Access Compliance Report Public Rights-of-Way (Pedestrian Signals)

Main Street: **OSO_PKWY** Cross Street: **MEANDERING_TRAIL** Location: **NW**

ADA ID: **SGRK211019150449** Signal Type: **One Push Button-APS** Overall Compliance: **No** Severity Scores: **BTN 1: 25** **BTN 2: N/A** **No BTN: N/A**

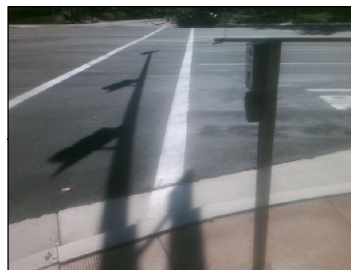
OC Std/PROW: **R404.2, R404.3**

Possible Solutions: Remove and Replace Clear Space.
